Addendum # 1

Bid Opportunity: 24-7556-RFT – Waterloo-Oxford District Secondary School Family Studies Renovation & HVAC Upgrades

.1 REFER TO THE ATTACHED MECHANICAL & ELECTRICAL ADDENDUM #1 PREPARED BY MNE ENGINEERING LTD. DATED 12 APRIL 2024 (9 PAGES).

To:	Cornerstone Architecture	Date:	April 12, 2024
		Project:	Waterloo-Oxford District Secondary School Family Studies Renovations & HVAC Upgrades
cc:	WRDSB	Project No:	24008

PROJECT:	WODSS FASHION STUDIES & HVAC UPGRADES	03	
DRAWING:	GAS PIPING REVISIONS	02	
DWG NO:	SK-M03	JOB NO:	24008
SCALE:	AS NOTED	DRAWING BY:	J.S.S.
DATE:	APRIL 2024	CHECKED BY:	K.K.
		01	ADDENDUM 01
		REV#	REVISION
		CLIENT:	CORNERSTONE ARCHITECT INC.

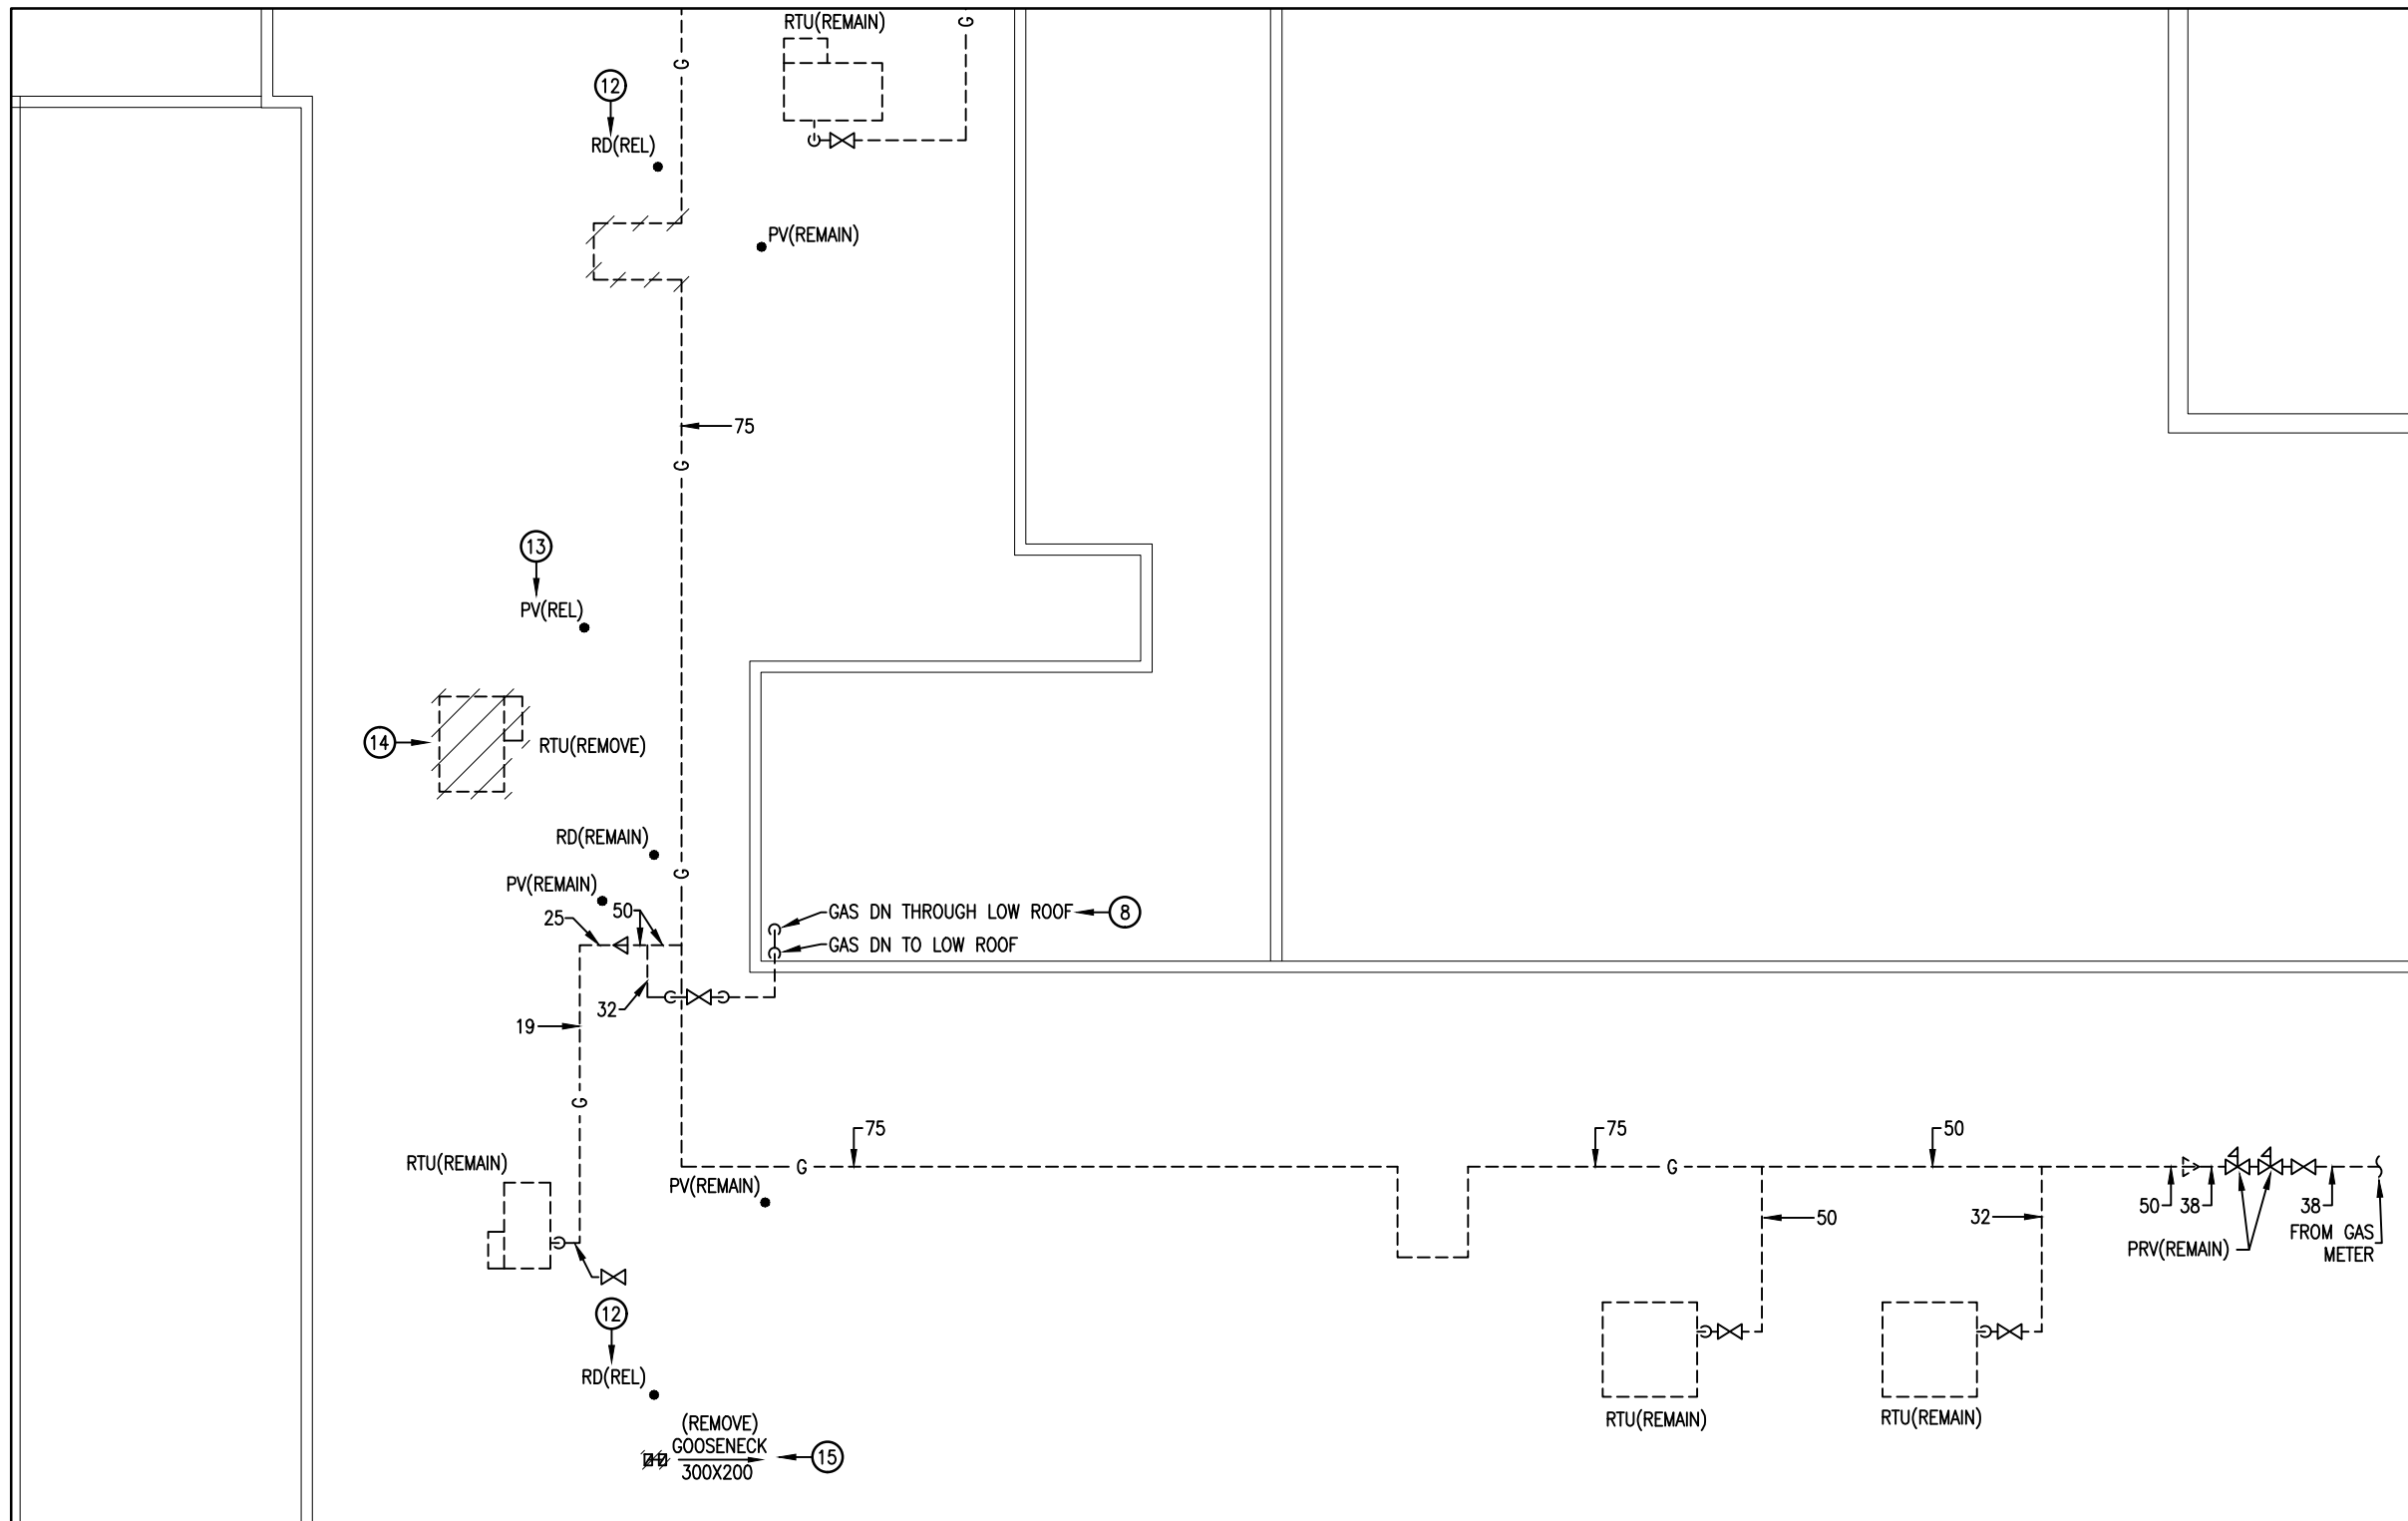
8. Reference 2/M2.2 and 2/M3.2
 - a. Revise gas piping on roof as per attached sketches SK-M03 and SK-M04.
 - b. In 517 Manufacturing/Machine, remove pneumatic controls for one fan coil (complete with one thermostat) and provide BAS controls.

PROJECT: WODSS FASHION STUDIES & HVAC UPGRADES	
DRAWING: REVISED ELECTRICAL PLAN	
DWG NO: SK-E01	JOB NO: 24008
SCALE: N.T.S.	DRAWING BY: A.T.
DATE: APRIL 2024	CHECKED BY: C.W.

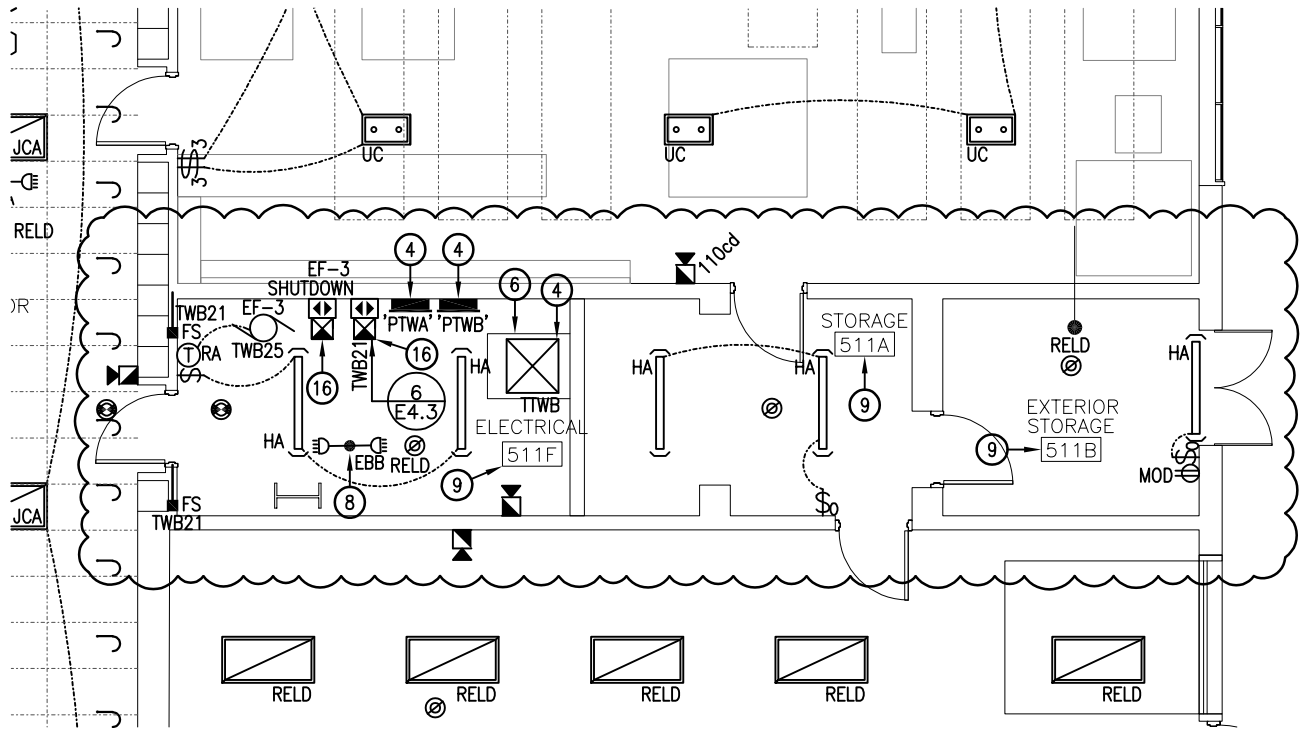
2. Reference 1/E3.1, E4.1 & SK-E01.

- a. Revise lighting controls within Exterior Storage 511B.
- i Delete provision of two three-way light switches.
 - ii Provide new wall mounted occupancy sensor type '\$O'.

- b. To accommodate the newly created Electrical Room 511F:
- i Rework existing ceiling mounted conduits to accommodate new wall installation. Wall by others. Seal all rated penetrations.

- ii Relocate new distribution equipment. Coordinate installations with existing compressor and existing mechanical equipment.
 - iii Relocate horn/strobe to 511F.

- iv Relocate two of the new type 'HA' luminaire in 511F.
 - v Relocate one of the new type 'HA' luminaire in 511A.
 - vi Provide one additional type 'HA' luminaire in 511A.

- vii Delete provision of two three-way light switches.
 - viii Provide one wall mounted occupancy sensor type '\$O' in 511A.
 - ix Provide one light switch in 511F.

- x Delete provision of one type 'EBA' emergency luminaire.
 - xi Provide one type 'EBB' emergency luminaire in 511F.
 - xii Relocate the one heat detector labeled 'RELD' to 511F.

- xiii Provide one new heat detector in 511A.
 - xiv Provide the following for new exhaust fan EF-3 (120V-1PH, 1.6A). Coordinate with mechanical.
 - Provide 15A-1P breaker and branch wiring from TWB25.

- Install new reverse acting thermostat for controls. Thermostat supplied by mechanical trade.
 - Provide electrical connections from TWB21 for two additional fire-smoke dampers between the wall of 511F & 813.

- Provide a fire alarm relay for shutdown of EF-3.

- Provide one new ceiling mounted smoke detector in 511F & one new ceiling mounted smoke detector in 813. Smoke detectors shall be mounted within 1.5m of new fire-smoke dampers.
 - Interlock new smoke detectors with smoke dampers. Refer to 6/E4.3 for fire smoke damper wiring schematic.
 - Revise key plan note 'K1' to include an additional initiating zone: Exhaust Fan EF-3.
3. Reference 1/E2.1 & 1/E3.1.
- a. Relabel DECORATING ROOM 515A to STORAGE ROOM 515A.
 - b. Relabel DECORATING ROOM 515B to STORAGE ROOM 515B.
4. Reference 1/E3.2, Wiring for Equipment Schedule, Panel 'TWB' Schedule, and Panel 'TWA' Schedule.
- a. Revise EF-1 requirements as follows:
 - i 600V, 3PH, 3.9FLA.
 - ii Delete provision of new 15A-3P breaker and branch wiring from TWB15,13,17.
 - iii Provide 15A-3P breaker and branch wiring from TWA19,21,23 for EF-1.
